Wichita-Sedgwick County Metropolitan Area Planning Department

RE: BZA 2000-00021 – Variance to allow a building sign without 150 feet of parking lot between buildings. Generally located north of 21st Street North on the east side of Tyler.

SECRETARY'S REPORT

CASE NUMBER: BZA2000-00021

Site Plan
1" = 40'-0"

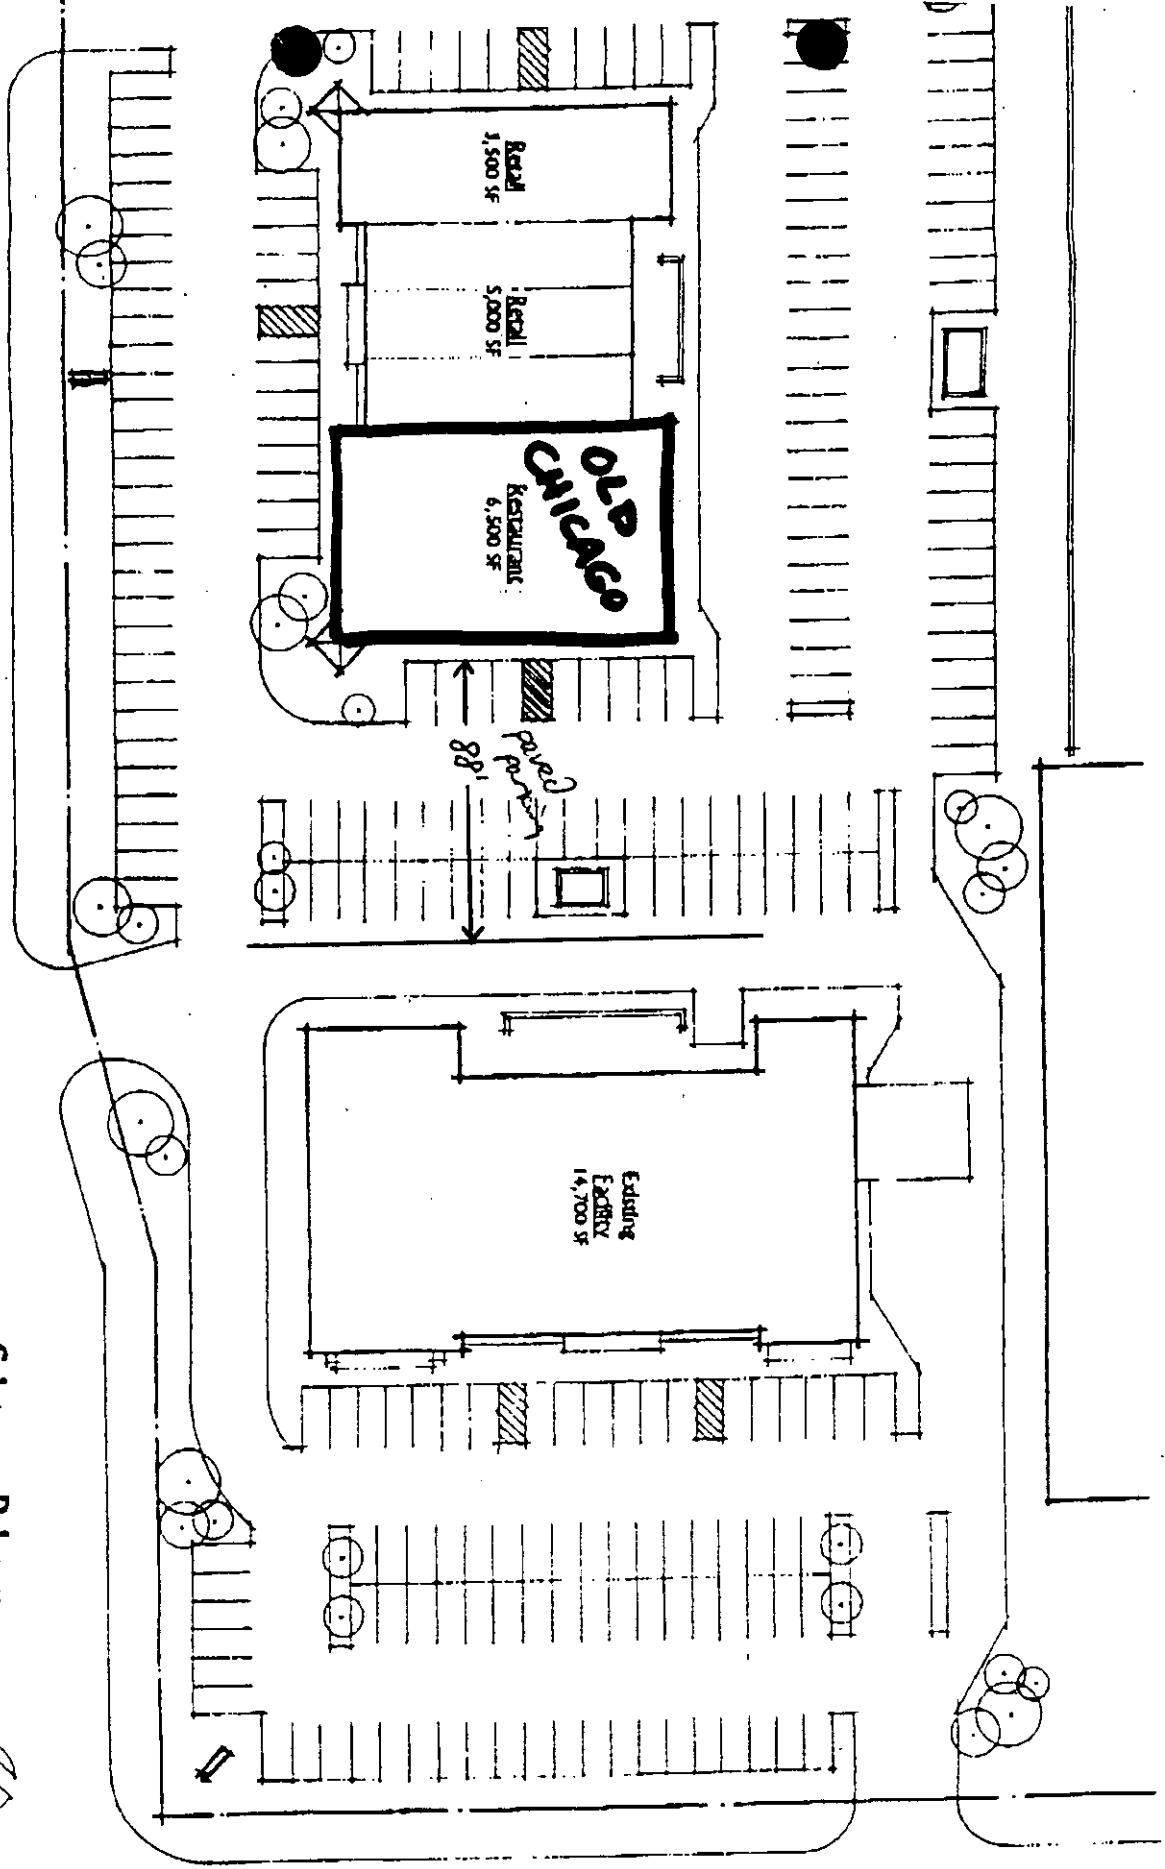
BACKGROUND: The applicant is requesting a variance for proposed building sign on the south elevation of an Old Chicago Restaurant under construction north of 21st Street North on the east side of Tyler. The south elevation of this building is less than 150 feet from the building to the south (Restaurant & Retail), which triggers the need for this variance. The space between the two structures (approximately 100 feet) is used for parking and driveway.

The building sign proposed for this location is a 128 square foot sign on the south elevation of the building. Per the sign code the commercial strip center is permitted a 30-foot tall, 200 square foot pole or monument sign along Tyler. In fact the applicant has been issued a permit for a Tenant Board for this location that is 20 feet tall and 10 feet wide. The applicant is also permitted a building sign along the Tyler measuring no more than 20 percent of the tenant lease area front elevation. The applicant has received a permit for two building signs along the Tyler frontage for this tenant – one measuring 136 square feet and the other measuring 34 square feet, which will be placed over the entry way to the restaurant. Per the Sign Code, the applicant still has the opportunity to erect a 15 square foot sign on the south elevation, which would be in line with the scale of the parking area that exists to the south and would still facilitate identification of the restaurant for patrons using that parking area.

UNIQUENESS: It is the opinion of staff that this property is not unique, inasmuch as the site has ample opportunity for signage and visibility along Tyler. The addition of a sign along the south elevation would not provide any additional visibility along 21st Street North or Tyler.

RECOMMENDATION: It is staff's opinion that this site has ample signage per the existing Sign Code regulations and the conditions necessary to granting the variance do not exist. It is the recommendation of the Secretary that the variance to allow a building sign on the south elevation be DENIED.
